# **Mobile Pentium® II Processor Specification Update**

Release Date: January 1999

Order Number: 243887-006

The Mobile Pentium® II processor or the Intel® Pentium II Processor Mobile Module may contain design defects or errors known as errata which may cause the product to deviate from published specifications. Current characterized errata are documented in this Specification Update.

**Figure 2. Workaround Flowchart: SMBALERT#-Driven System**

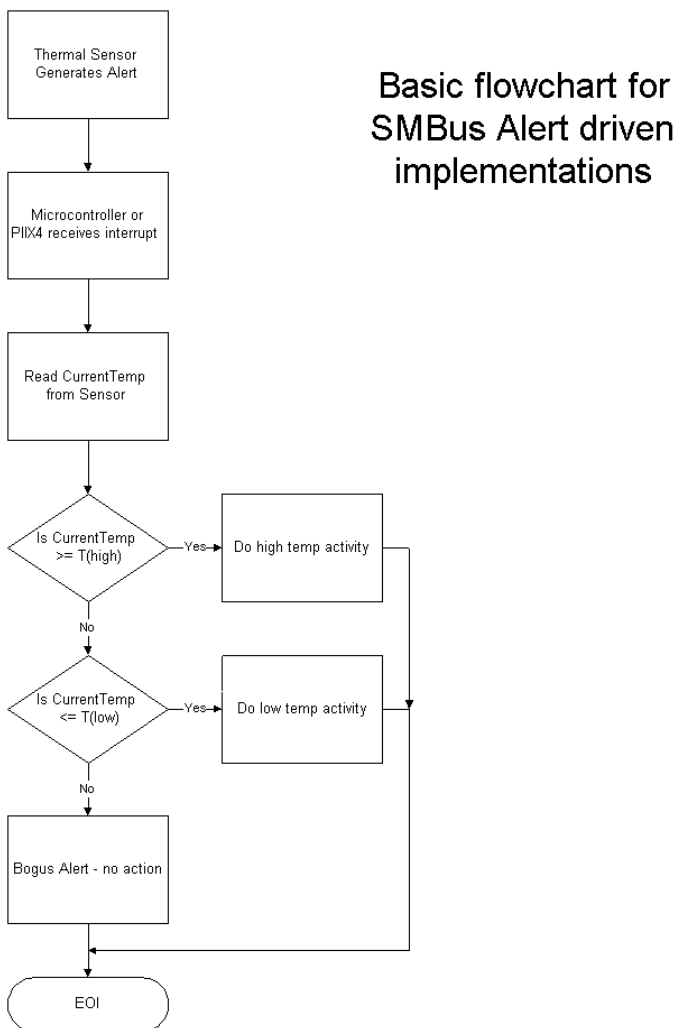
## B30. Thermal Sensor May Assert SMBALERT# Incorrectly

Under the conditions described below, the thermal sensor incorrectly generates the SMBALERT# interrupt. *All* of the following conditions must be met to trigger a false interrupt:

**WORKAROUND:** Three different (mutually exclusive) workarounds are possible:

1. Before servicing an interrupt from the thermal sensor, read and compare the processor thermal reading with the threshold limits ( $T_{HIGH}$  or  $T_{LOW}$ ). Figures 2 and 3 provide basic flowcharts for the implementation of this workaround in an interrupt driven system.
2. If the firmware implemented polls the Status Register only, then before taking any action, re-read the temperature register and do a comparison with the alarm threshold limits ( $T_{HIGH}$  or  $T_{LOW}$ ) to determine if the value is actually still within the temperature window.
3. Use a temperature polling scheme to monitor the processor temperature.

Figure 5.6. Cross Sectional View With Vertical Dimensions

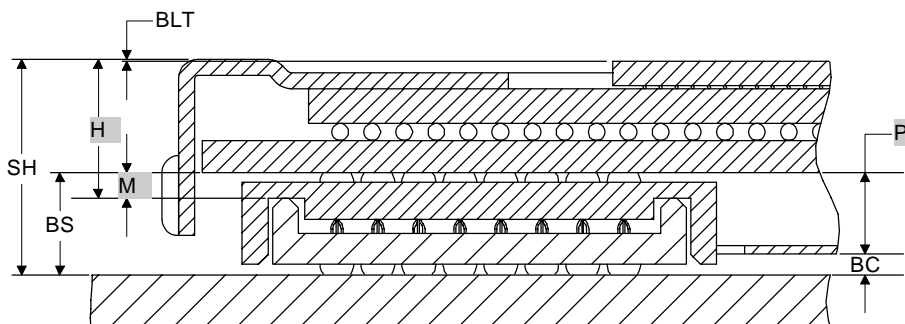
**B12. Misabeled Vertical Dimension Parameters**

Figure 5.6 in the *Mobile Pentium® II Processor at 233 MHz, 266 MHz, and 300 MHz* datasheet should be replaced by the following figure:

Symbol	Parameter	Min	Nom	Max	Units	Figure
H	Processor Height	4.40	4.55	4.70	mm	5.6
M	Plug Height	0.91	1.03	1.15	mm	5.6
P	<b>Bottom Cover Height</b>	--	<b>2.54</b>	<b>2.81</b>	<b>mm</b>	<b>5.6</b>
BLT	Bond-Line Thickness	0.01	0.12	0.23	mm	5.6

- See Table 5.3 and Figure 5.6 for the definitions and illustration of processor height, plug height, bottom cover height and bond-line thickness.
- Processor height, plug height, bottom cover height and bond-line thickness are the only monitored vertical dimensions. The other dimensions in Figure 5.6 are dependent on the receptacle height. Refer to the *Mobile Pentium® II Mechanical and Thermal Design Guide* for information on the effect of receptacle mounting technique on these dimensions.
